# ADDENDUM NO. 2

**July 25, 2022**

**LIBERTY AND WESTCHESTER INTERMEDIATE SCHOOLS -  
ATHLETIC SITE PROJECTS  
Chesterton, IN 46304**

## ADDENDUM TWO

### TELECOMMUNICATIONS BACKBONE DIAGRAM WESTCHESTER NTS

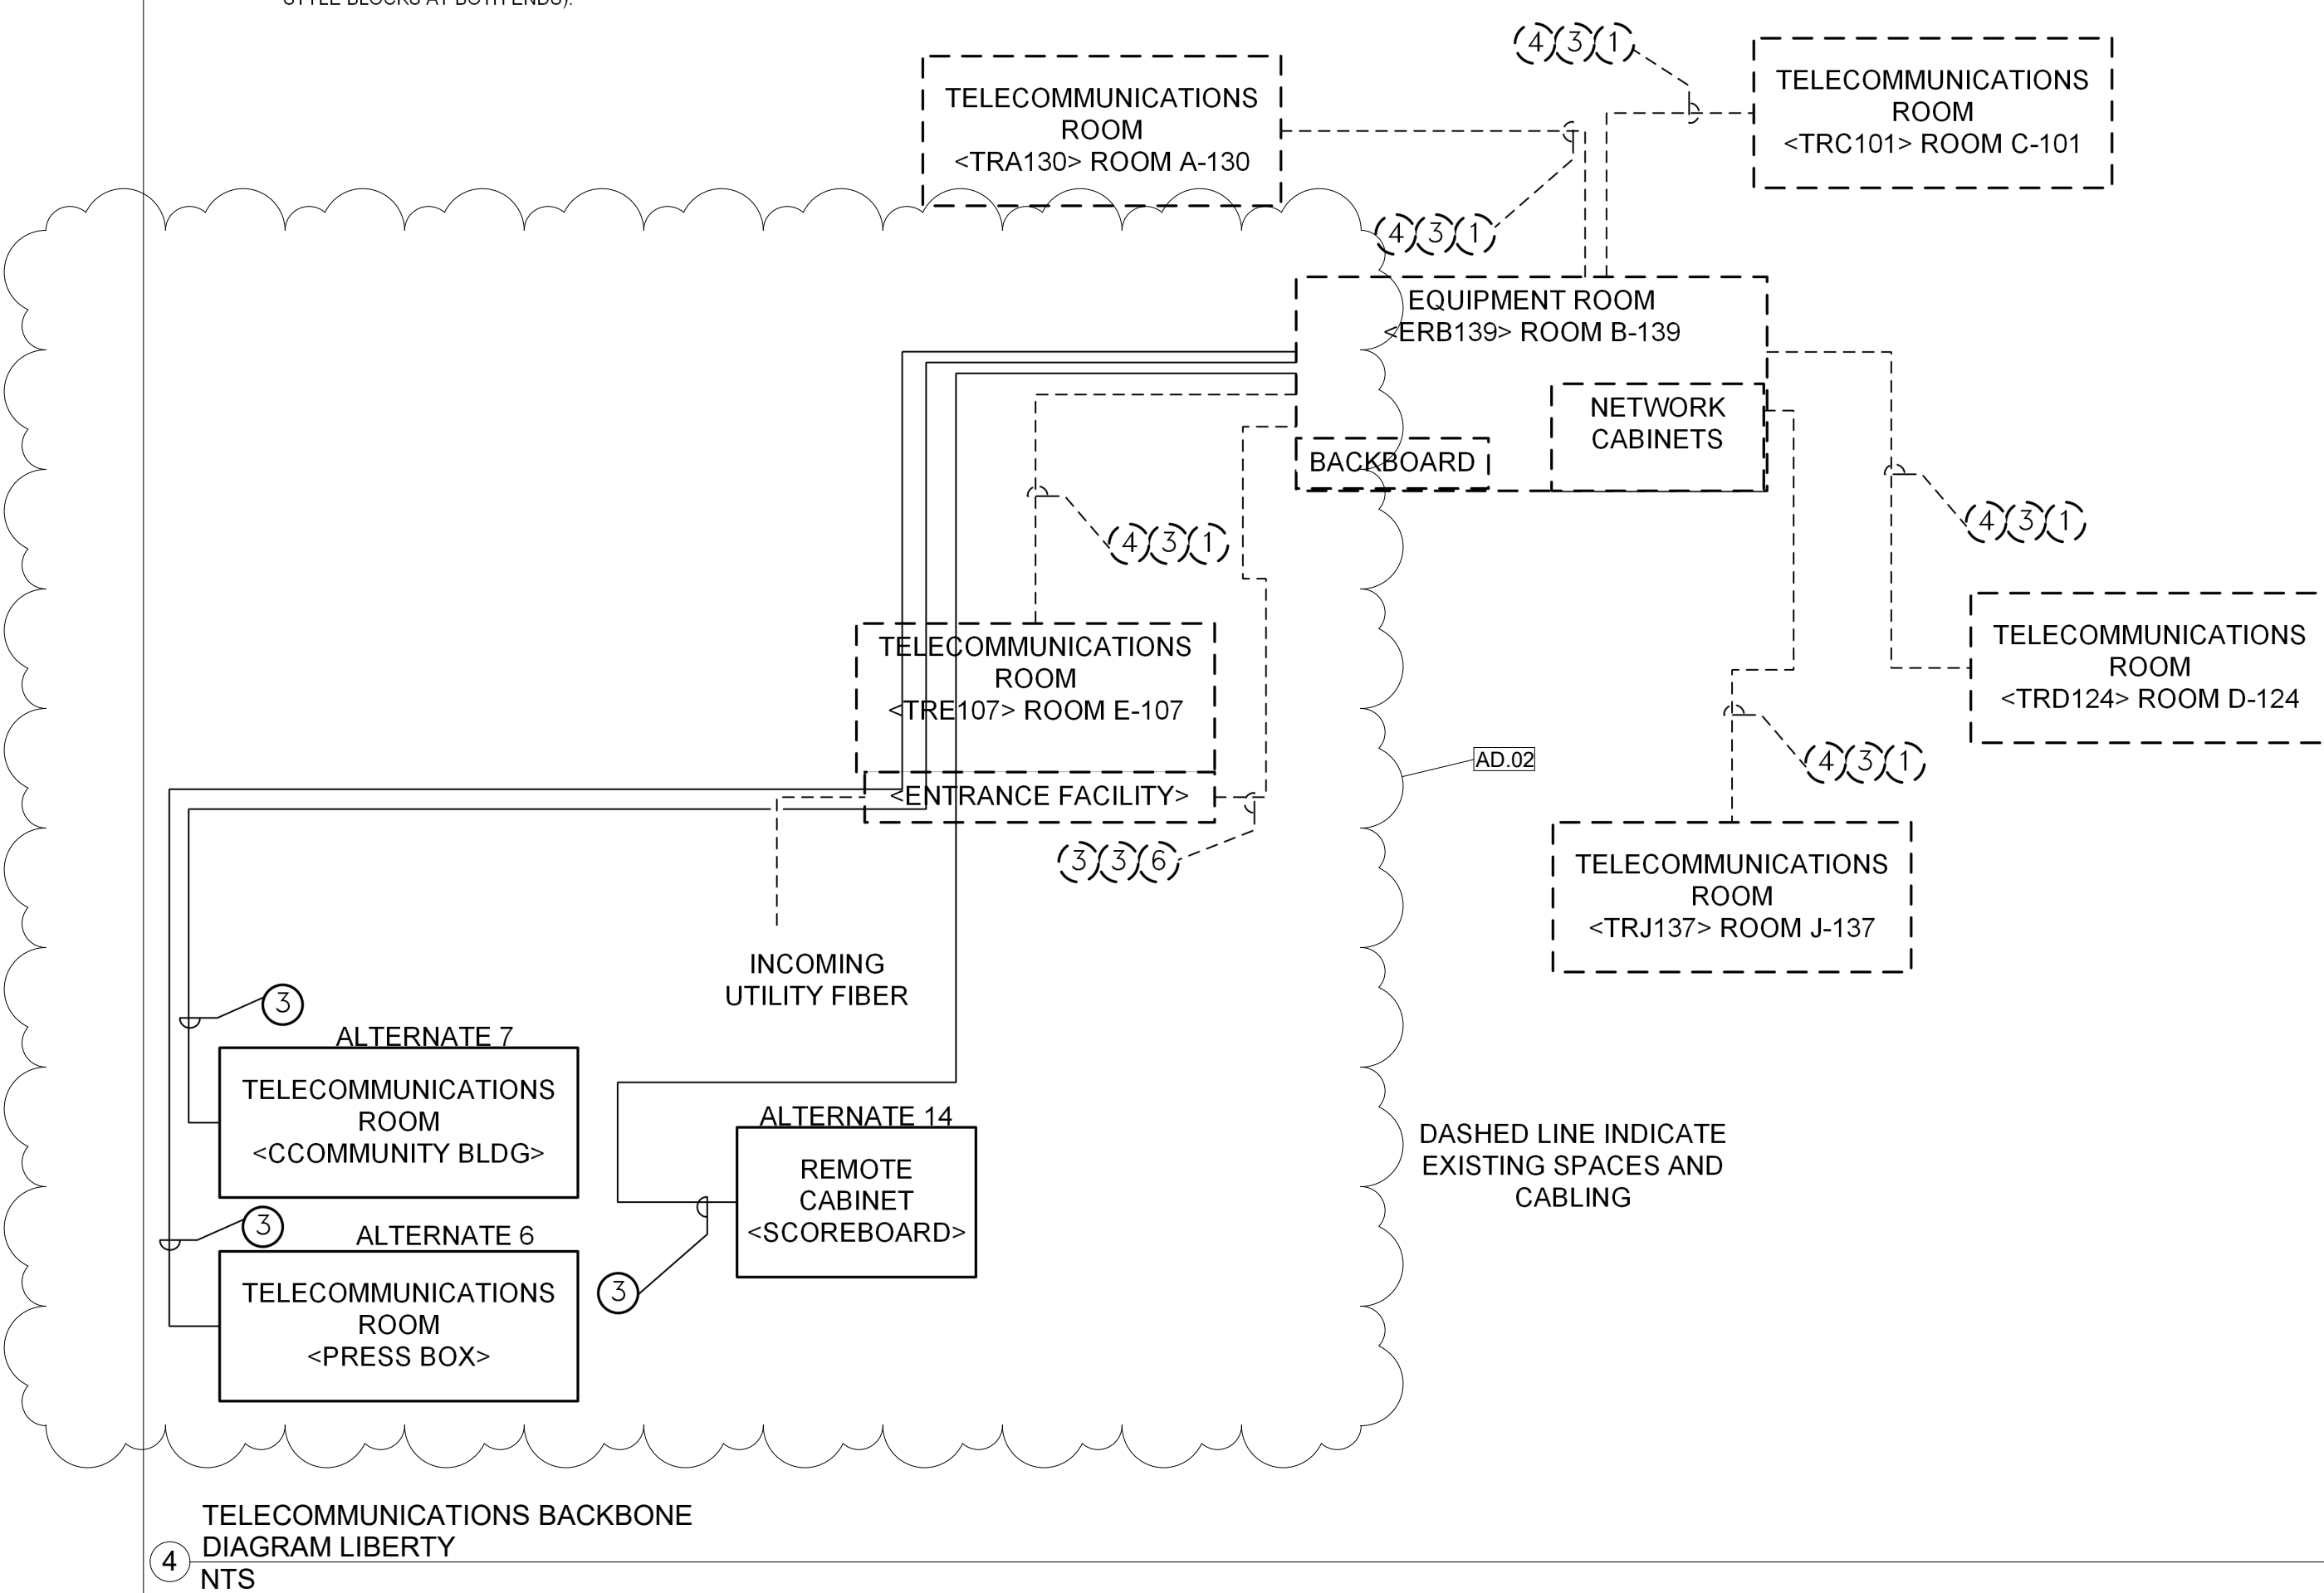
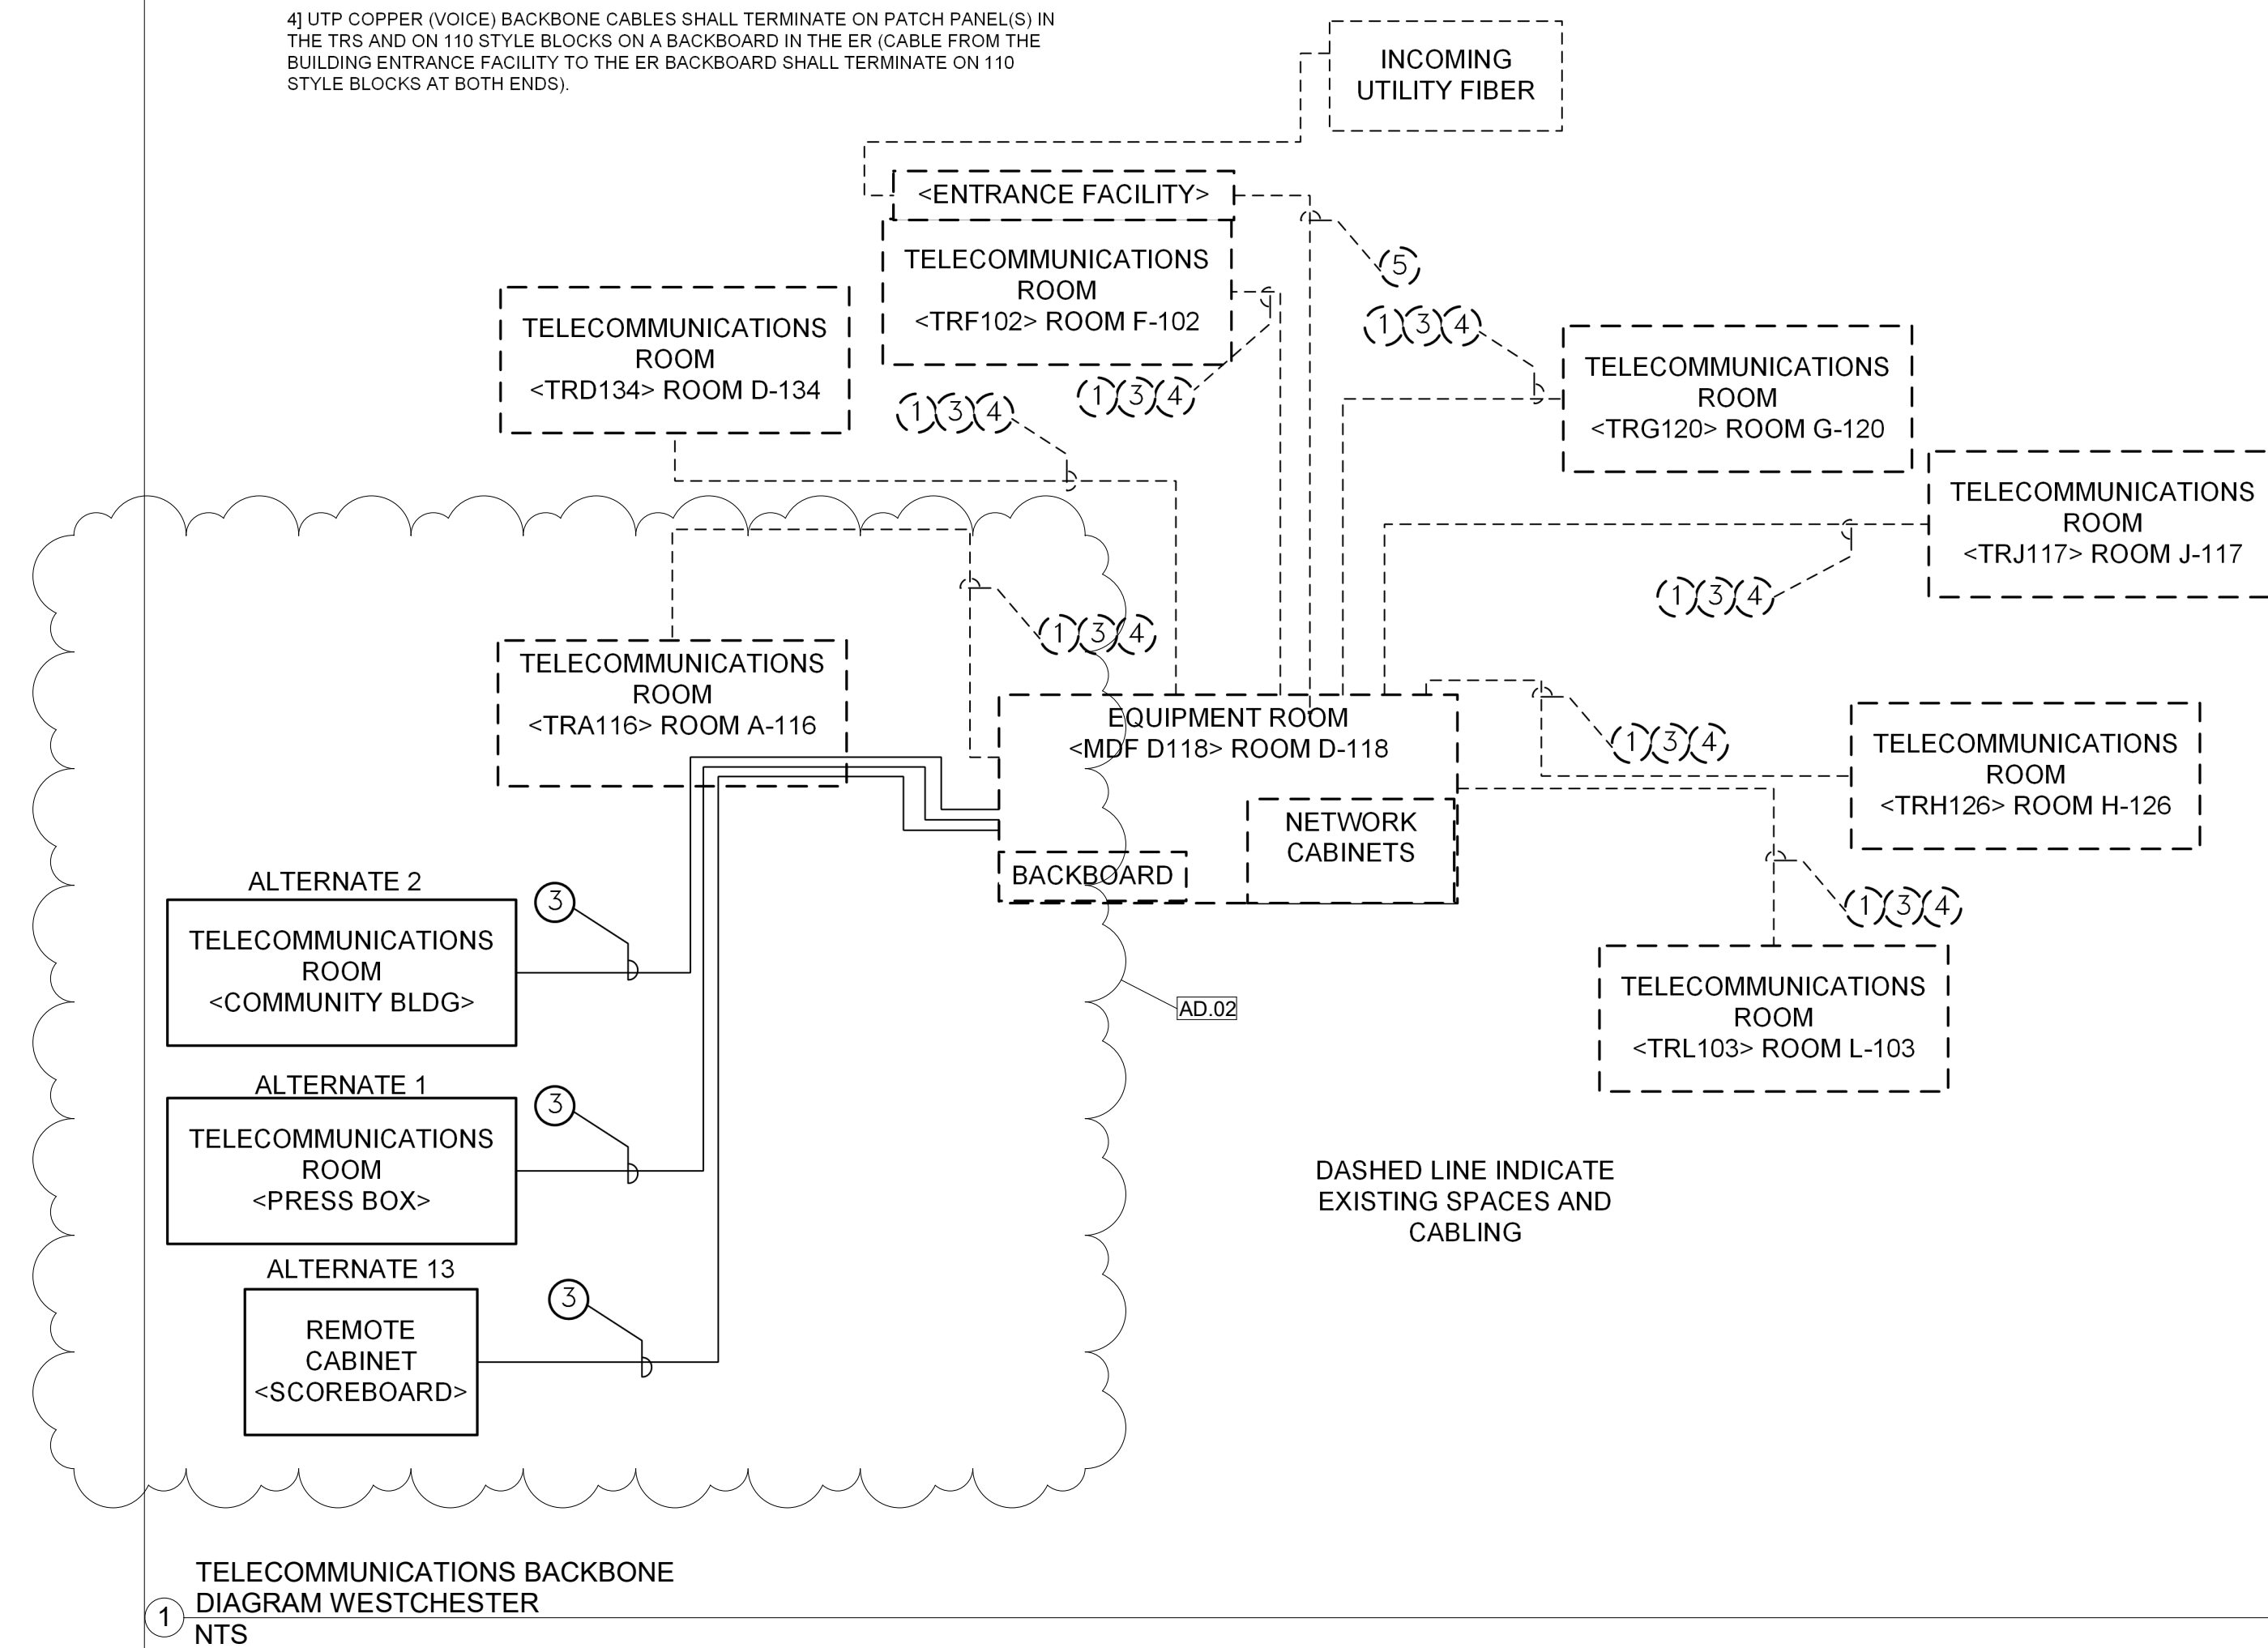
- A. Replace Sheet TS-601 with full-size drawing included in this addendum.
  - 1. Added notes to clarify scope of work breakdown between base bid and alternates.
